**P22-19**  
**Hotel Redevelopment**  
**REVISED**

Property Owner: Legacy Hotel of Medina LLC  
Applicant: Jim Gerspacher  
Location: 253 and 257 South Court Street  
Zoning: C-2 (Central Business)  
Request: Revised Conditional Zoning Certificate and Site Plan approval for the construction of a hotel

The current application revises the footprint and height of the hotel building, updates building elevations, and provides greater detail. In addition, the proposed hotel incorporates a first floor restaurant, four stories of hotel rooms, a partial fifth story with a rooftop lounge, and a small one-story area located at the rear of the building for deliveries. The proposed revision does not alter the previous approval of P24-09.

Plan View  
Scale - 1" = 25ft

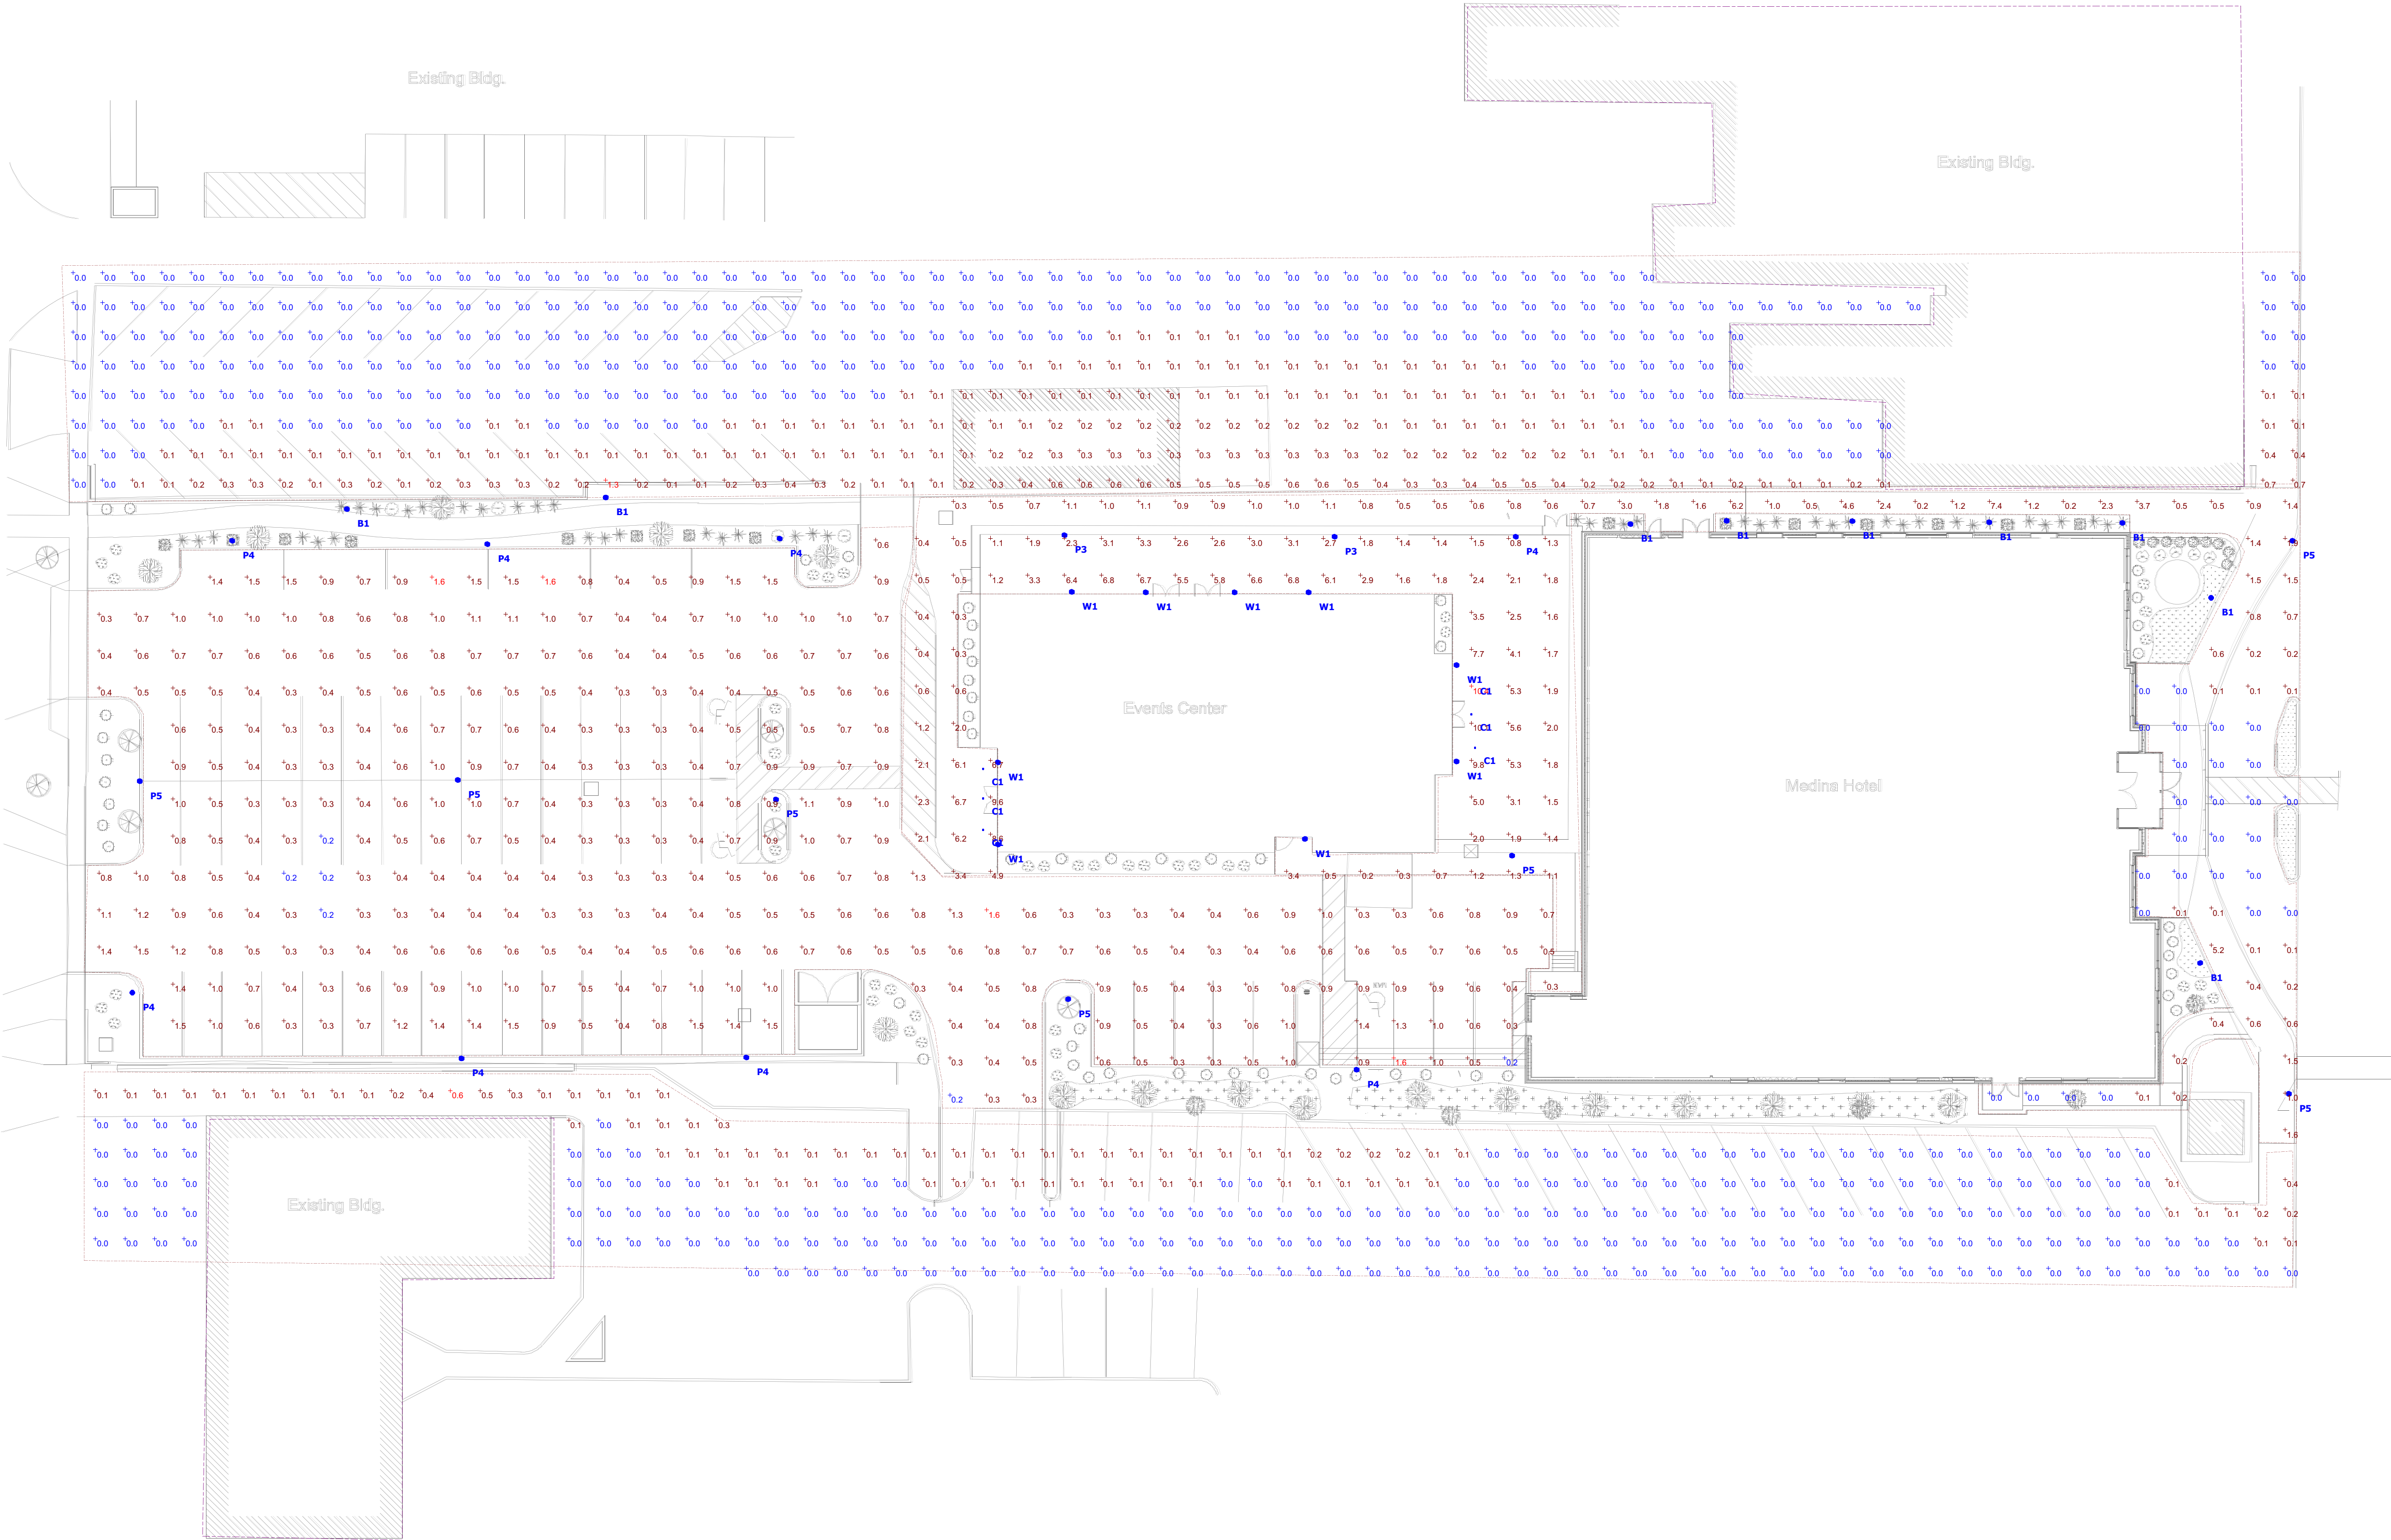
A lighting plan was approved with P24-09 with 15 ft. light fixtures and a compliant photometric plan. Lighting plans have been provided consistent with P24-09. It should be noted that two lights noted as "P5" located in the right-of-way will need to be replaced with lights matching existing street lights along South Court Street.

2. Two lights noted as "P5" located in the right-of-way shall be replaced with lights matching existing street lights along South Court Street
3. Use, improvements, or access to the public right-of-way or City Parking Lot #4 shall be authorized in a format determined by the City Law Director.
